Reviewed
 Reviewed as noted
 Revise and resubmit
 Not Reviewed
 Date: Aug 9/15
 Reviewed by: M. Brown

Package 11 - Level 10

PROJECT NAME: SQ ALEXANDRA PARK - BLOCK11
 DRAWING TITLE: 10th FLOOR ELEVATIONS
 ARCHITECT: TEEPLE ARCHITECTS
 CONTRACTOR: TRIDEL
 SCALE: 1:50
 DRAWN BY: S.C.
 DATE: MARCH 4, 2015

DRAWING No.:
E10-8

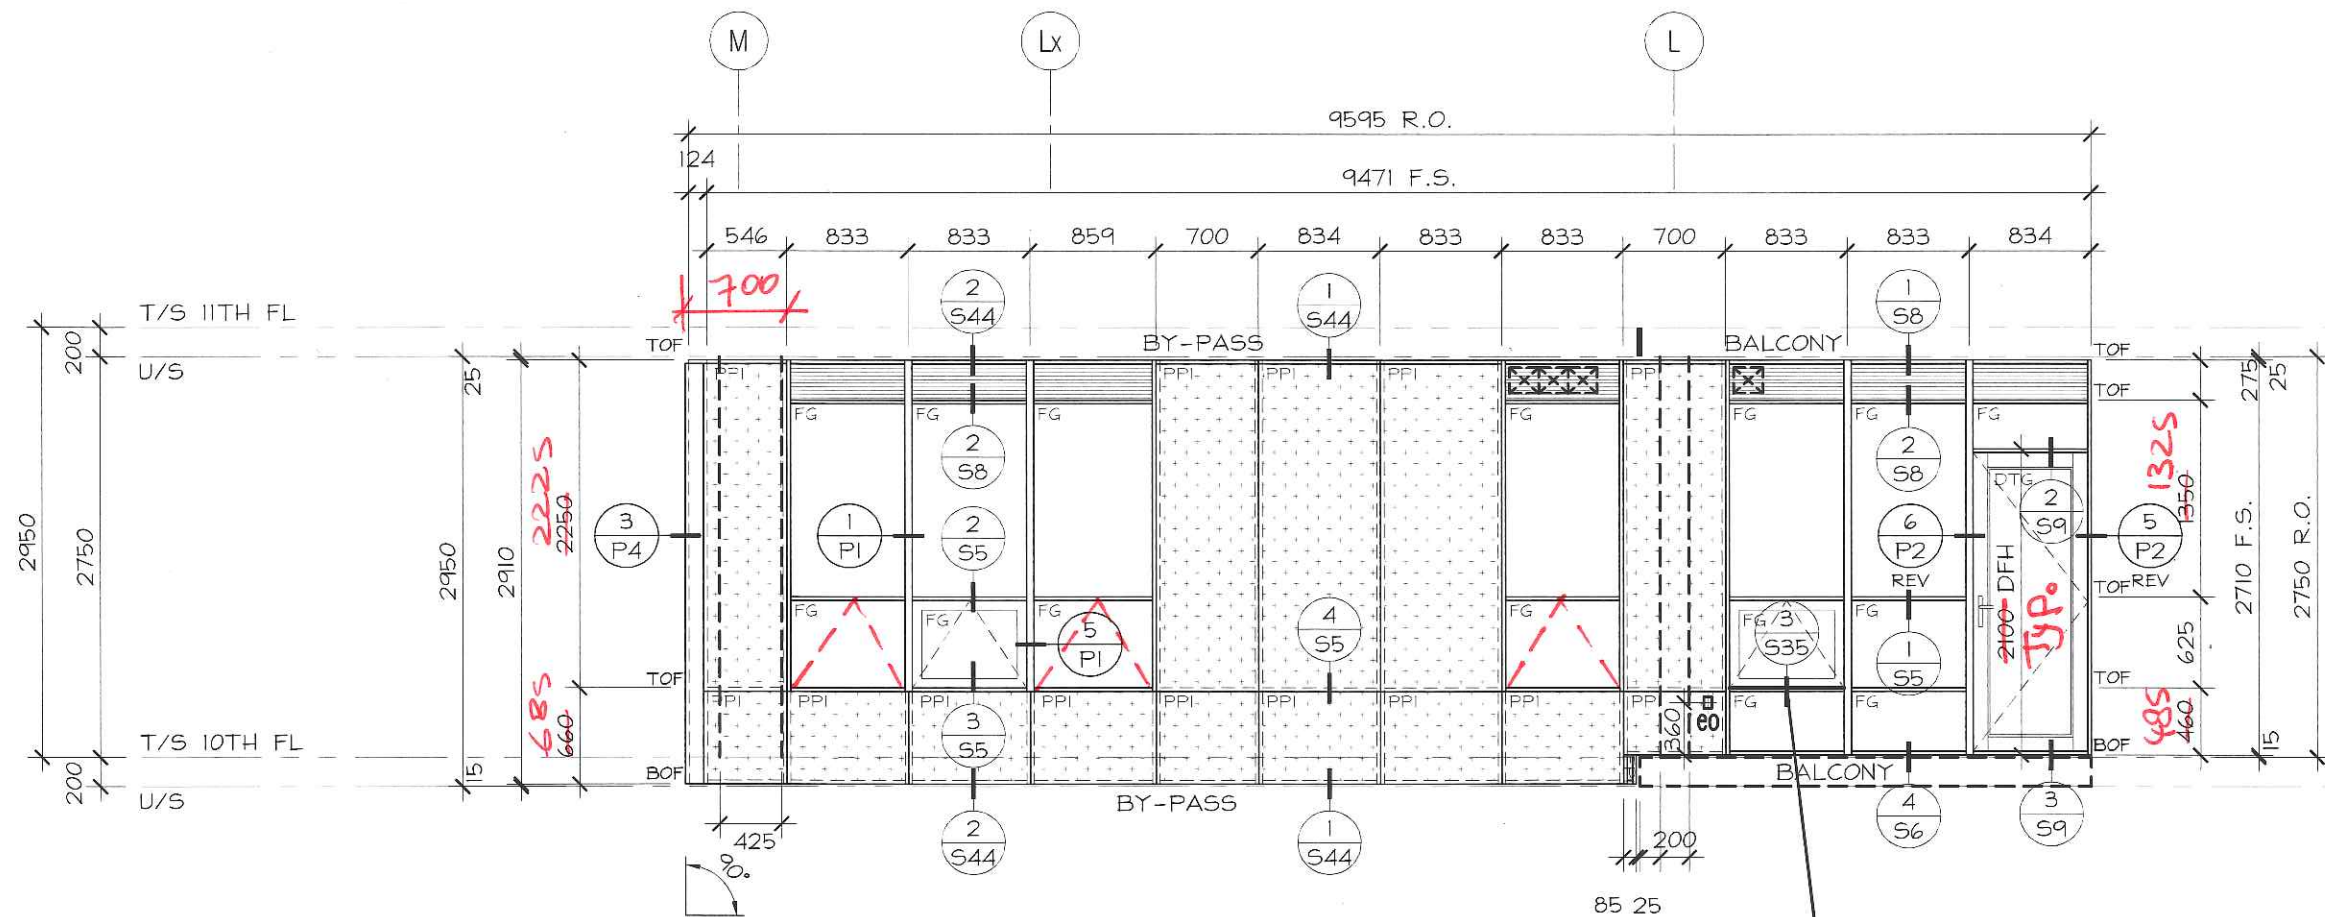
TOE GUARD
REQUIRED
